## Service Bulletin RU\_SB013

**Author:** Alexander Gaiderov, Technical Support  
**Date:** 2003-12-29  
**Subject:** Triplets Display Flex Connector  
**Rating:** Level 1 & 2 Authorized

**Products:** V300, V500, V525

Diagram 2.0 Poron Pad Placement

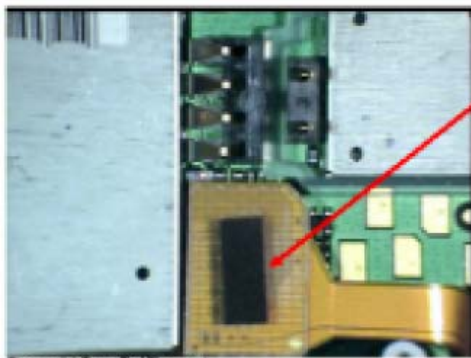
**Problem:** Service is aware of an issue with the Display Flex Connector on GSM Triplets Products. Various electrical failures, seen in ALT Testing after Drop Test, have been linked to a connectivity issue between the Display Assembly and the PCB at the J1300 connector. Failures are seen when the Display Flex becomes partially or completely separated from the J1300 connector.

Manufacturing has implemented the placement of a Poron Pad (7589188N01) directly on top and centered on the Display Flex at the connector. The added Poron Pad increases the pressure applied to the connector when assembled and reduces the chances of the Display Flex separating from the J1300 connector in the field. Please see Diagram 2.0 below for proper placement of the Poron Pad.

**Special Note:**  
Poron Pad should be placed centered across the top of the Display Flex at the connector

Diagram 3.0 New SIM Chassis Design  
NOTE: Image shows a V300 SIM Chassis and the Part Number is not valid!

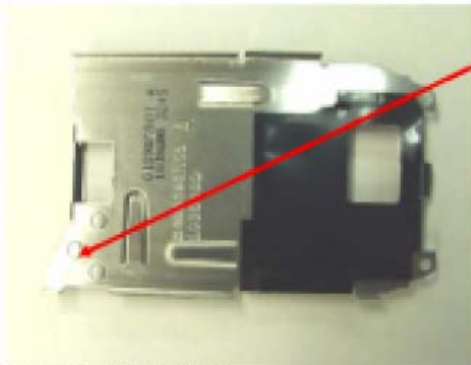
A re-design of the original metal SIM Chassis (0188940N01) has been requested by Hardware Development and will be implemented in manufacturing as soon as material with the new design is available. The new design will include three dented areas that extend further into the housing to add the appropriate amount of pressure to the connector to eliminate this type of failure. Diagram 3.0 below shows a sample of the SIM Chassis with the improved design.

**Special Note:**  
New Design with Three Dented Areas to apply pressure to connector
